AGENDA

4. **Badger Hill Properties LLC – Timber Ridge Dr – Map 50, Lots 26-124, 26-126, 26-128, 26-129, 26-131, 26-133, 26-160, 26-162, 26-164, 26-166, 26-167, 26-168, 26-169, 26-171, 26-173, 26-175, 26-177, 26-179, 26-180, 26-181, 26-182, and 26-183; Map 51, Lots 26-47, 26-123, 26-125, 26-126, 26-127, 26-152, 26-170, 26-172, 26-174, 26-176, 26-178, and 26-184; Map 55, Lots 26-130, 26-132, 26-134 thru 26-151, 26-153 thru 26-159, 26-161, 26-163 and 26-165.**

Date: June 17, 2014
To: Town of Milford Planning Board
From: Jodie Levandowski, Town Planner
Subject: **Badger Hill Properties LLC – Timber Ridge Dr – Map 50, Lots 26-124, 26-126, 26-128, 26-129, 26-131, 26-133, 26-160, 26-162, 26-164, 26-166, 26-167, 26-168, 26-169, 26-171, 26-173, 26-175, 26-177, 26-179, 26-180, 26-181, 26-182, and 26-183; Map 51, Lots 26-47, 26-123, 26-125, 26-126, 26-127, 26-152, 26-170, 26-172, 26-174, 26-176, 26-178, and 26-184; Map 55, Lots 26-130, 26-132, 26-134 thru 26-151, 26-153 thru 26-159, 26-161, 26-163 and 26-165.**

JOB NO: 4001-19 (T)
SHEET 3 OF 8

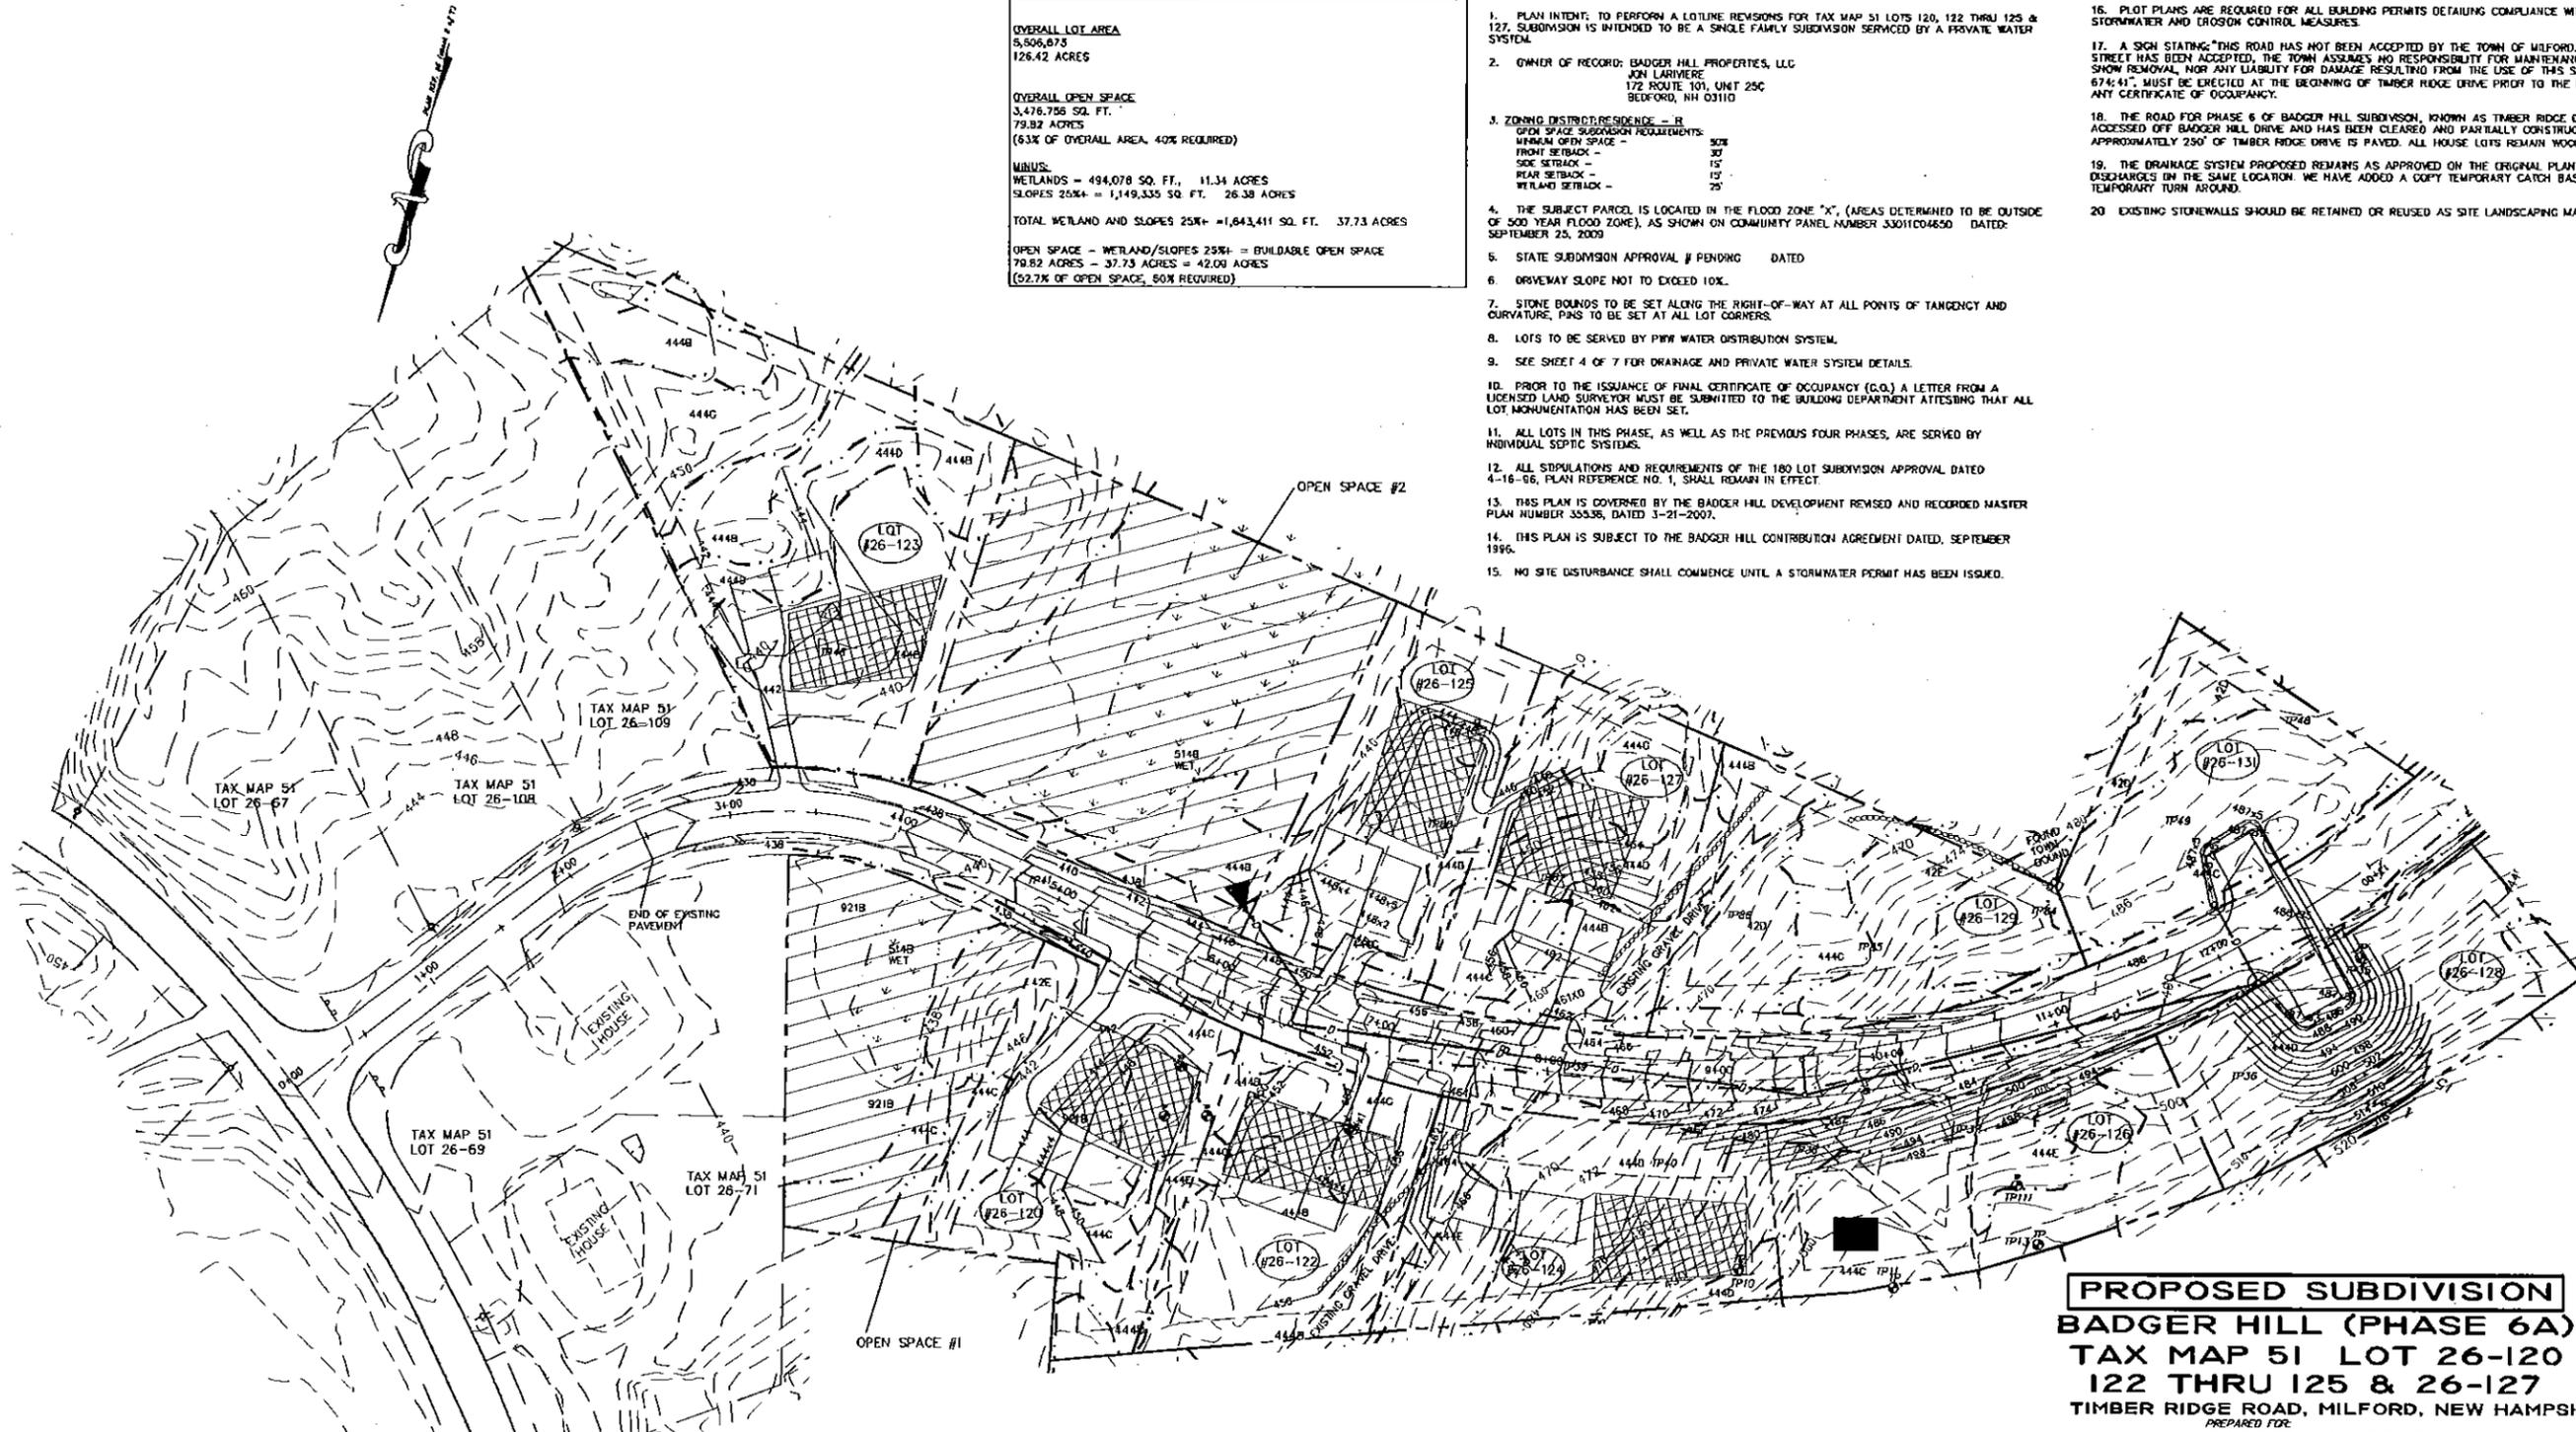
14. Plan notes on Sheet 3 of 7 under Open Space Calculations must be revised to read "NONBUILDABLE OPEN SPACE".

Response: See sheet 3 of 8.
